MISTER CAR WASH

SITE PLANNING SET

SITE PLAN SUBMITTAL

COVER SHEET (SITE PLAN)

SITE MAP
SCALE: 1"=60'

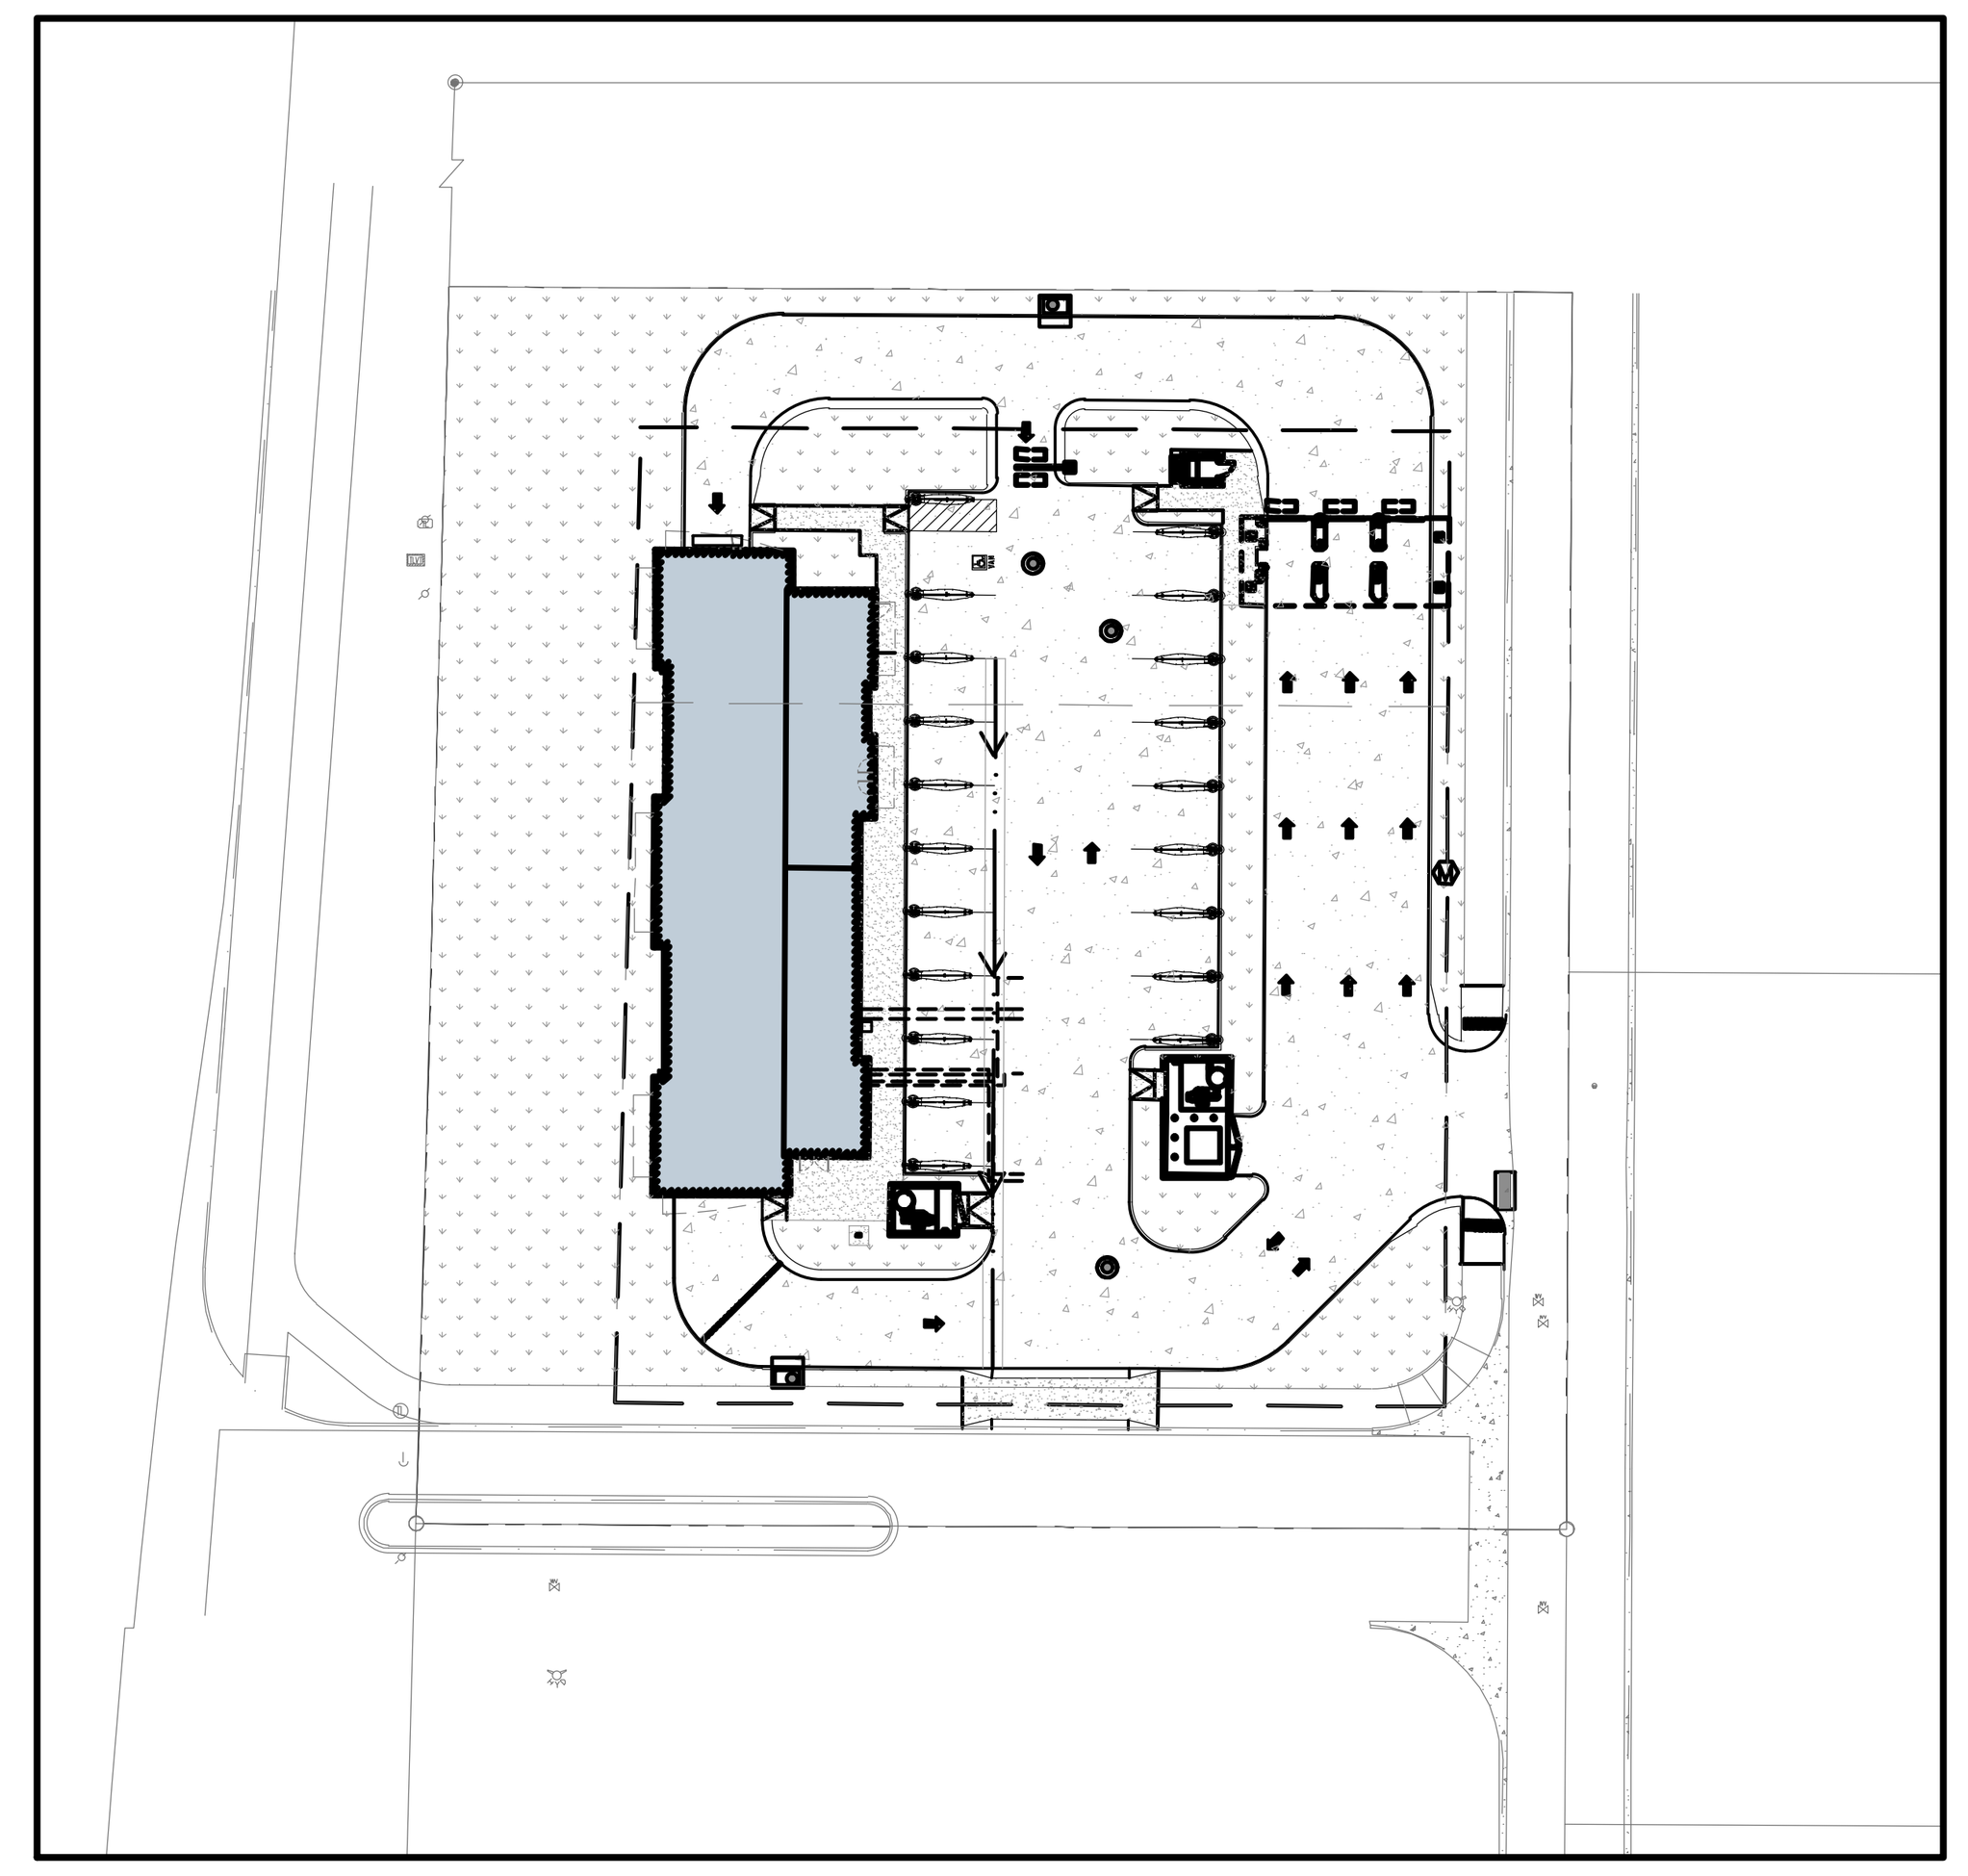
"Landscape"

list required/provided

vacuums must be removed from required parking

new LDO states 1 per bay = 2 stalls (1 must be ADA).

office space - need to calculate square footage, then apply parking requirements (1 stall per 300sf)

bike parking is required (ie, for employees) - 2 per 10,000 s.f. GFA, or 10% of vehicle spaces provided, whichever is lower, but not to require more than 10 bicycle spaces per retail tenant
